GROUP	MODEL
Safety Recall Campaign	2010MY Sportage (KM)
NUMBER	DATE
SC284KM	April 2024

SAFETY RECALL CAMPAIGN

HECU FUSE REPLACEMENT (SC284KM)

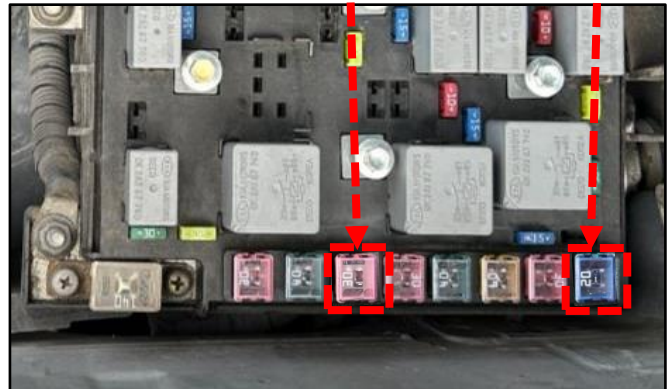
- 3a. Remove both existing HECU ABS1 40A (A) and ABS2 40A (B) fuses.

- 3b. Install new amperage fuses:

- ABS1 fuse (A) → new 30A
- ABS2 fuse (B) → new 20A

Ensure to replace ABS1 30A and ABS2 20A fuse.

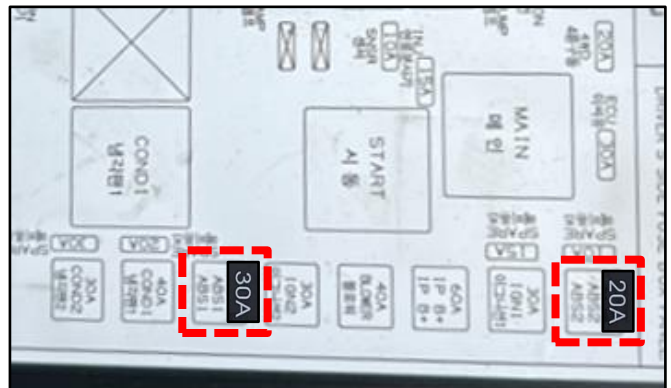
4. Adhere the new ABS1 30A and ABS2 20A labels to the bottom of the junction box fuse cover, as shown.
